**Responses to Request for Additional Information
Model No. WE-1 Package
Docket No. 71-9289**

Enclosure (1)
Responses to NRC RAIs

Figure 2.10-5 Finite Element Model for Armor Plate Inner Container
Original Configuration With All Three Clamps

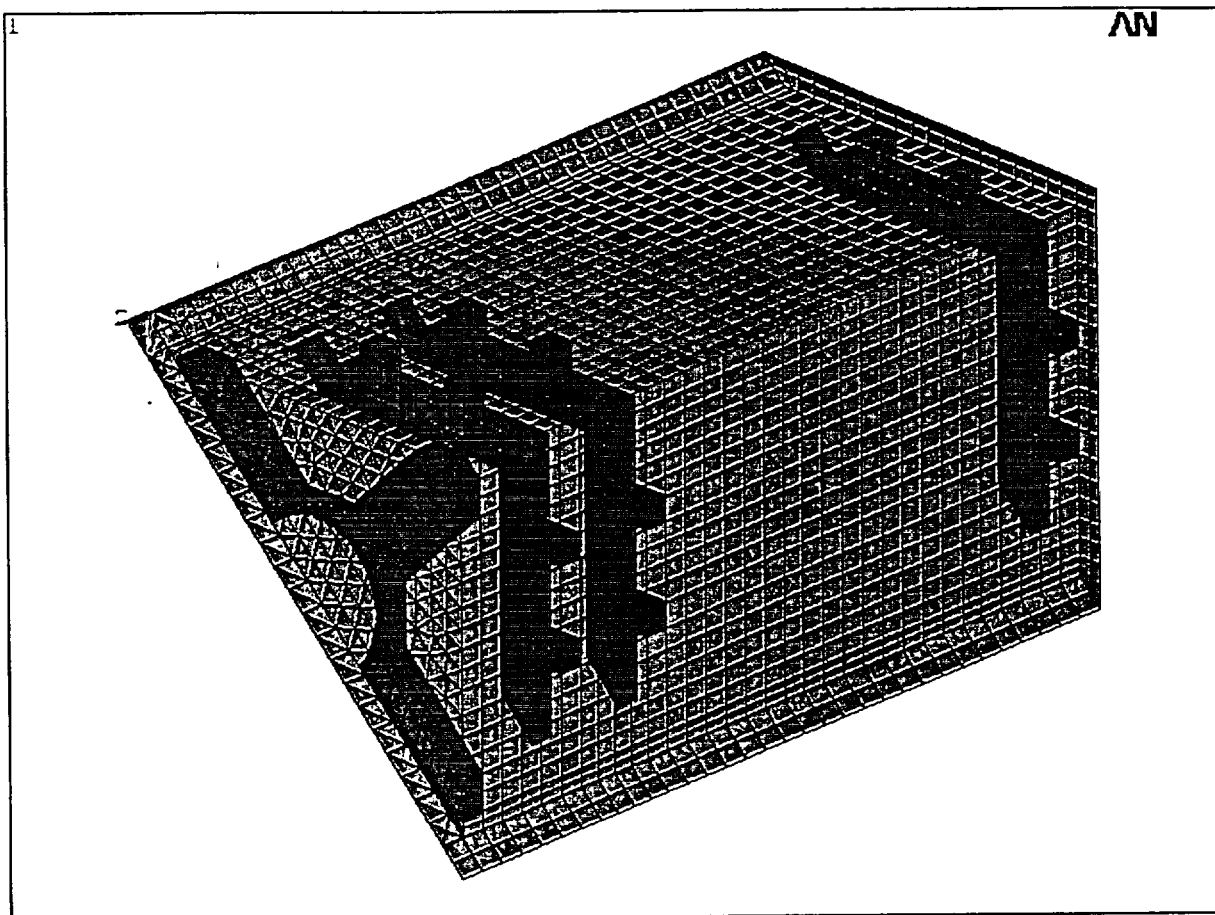
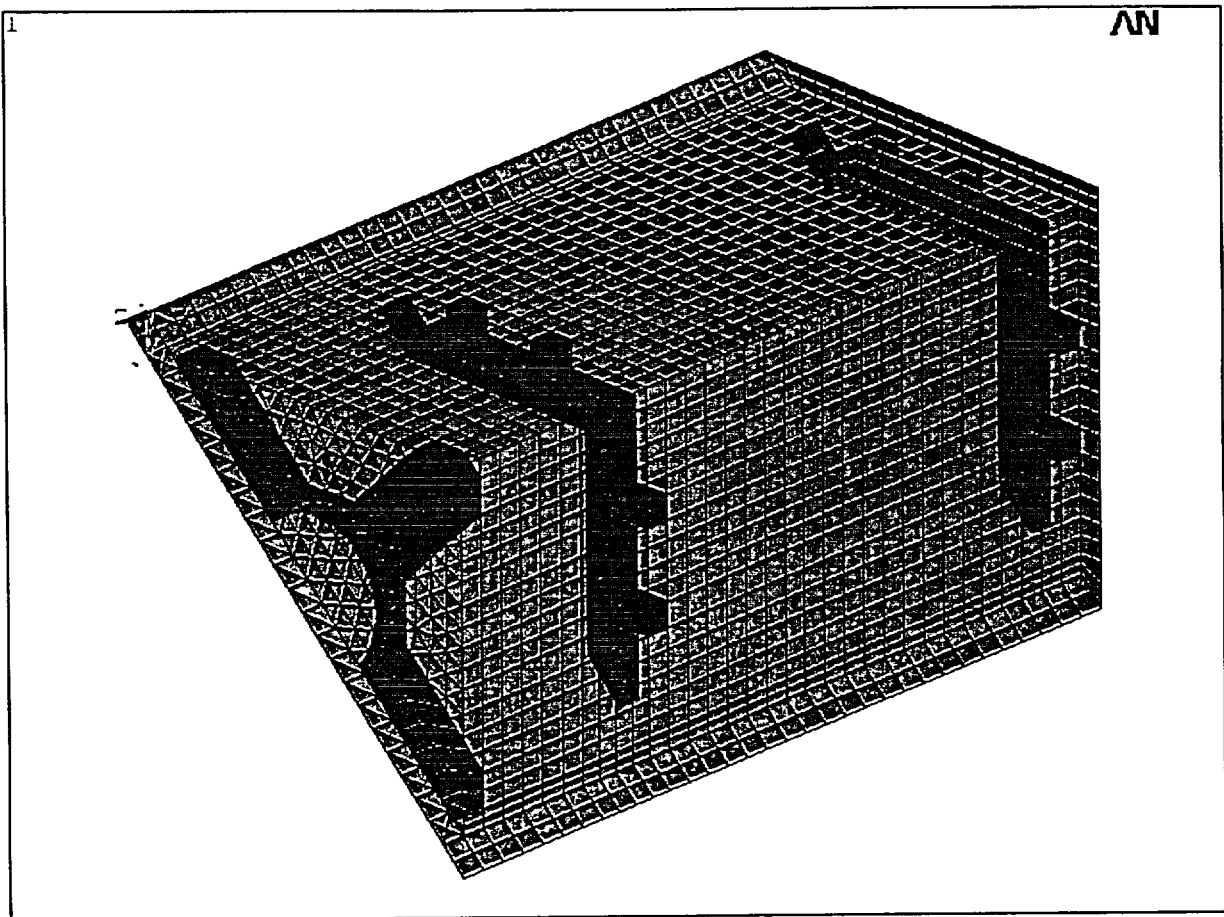
- 2-10 *Provide the bases of the statements in Section 2.10.2.8, regarding the adverse effects of the removal of one clamp in the Pathfinder fuel canister arrangement. The statements relate to the effects on the stiffness and resulting impact accelerations, and the adequacy of the high strength bolts in the new configuration.*

Section 2.10.2.8 discusses the effects of removing one clamp at the end, but does not provide any bases to support the statements related to the effects on the stiffness and the g-level, and the replacement of the low-strength bolts with the high-strength bolts. This information is required to verify that the package meets 10 CFR 71.33 requirements.

the inner container. This was verified by the computer analysis. There is no change in the beam bending stiffness with or without the end clamp. Also, when one considers, all of the other structural members, the change in the overall stiffness is insignificant. The stiffness calculation methods, analysis, and result are included in Section 2.10.2.8 of the SAR.

Figure 6-1b
Pathfinder Fuel Assembly Configuration

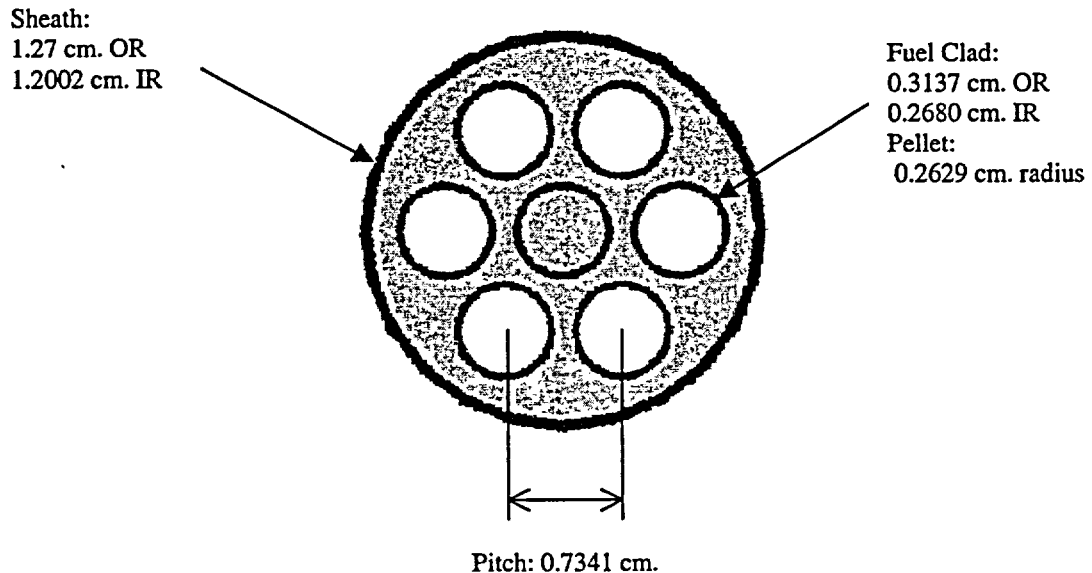
- 6-3 *Revise the diagram in Figure 6-1b to specify the dimensions used in the KENO criticality model.*

Figure 6-1b has been revised to show center-to-center pin pitch, fuel clad IR and OR, Sheath IR and OR, and Fuel pellet radius.
